SAFETY RECALL BULLETIN

NHTSA RECALL 18V-165, Transport Canada 2018-131

AUTOCAR, LLC SAFETY RECALL ACX-1801

Autocar has determined that a safety defect may exist in the routing of the methane detector sensor harness and/or the circuit detector fuse on 2014-2018 Xpeditor vehicles which could lead to an overcurrent condition.

Figure 2, Methane detector sensor harness (undamaged)

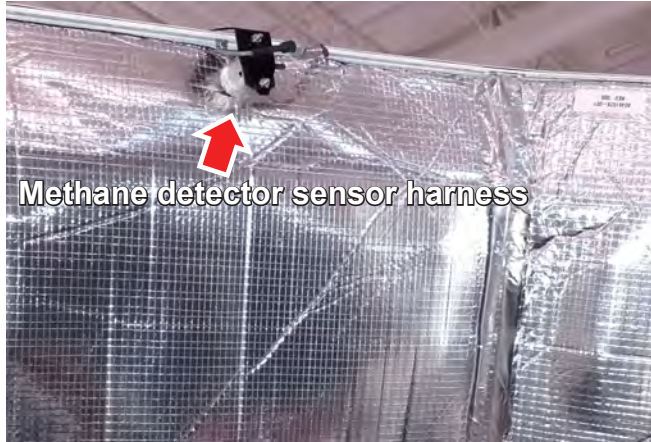
2. In the engine tunnel area of the raised cab, inspect the methane detector sensor harness (see Figure 1 and Figure 2).

Figure 3, Methane detector sensor harness (damaged)

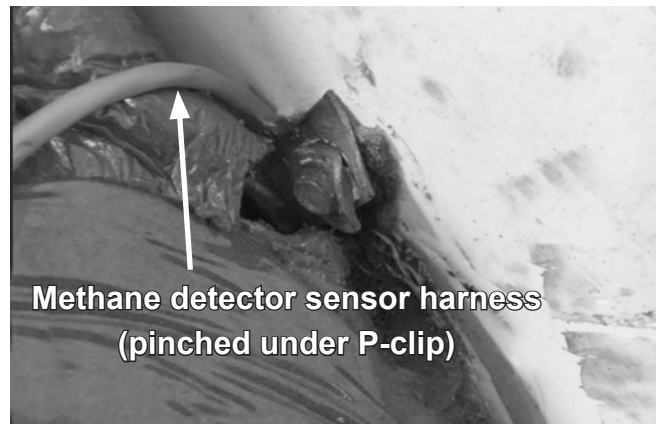
If damage is found to the methane detector sensor harness, contact Autocar technical support at 888-218-3611 for assistance with repair. (see Figure 3 and Figure 4).
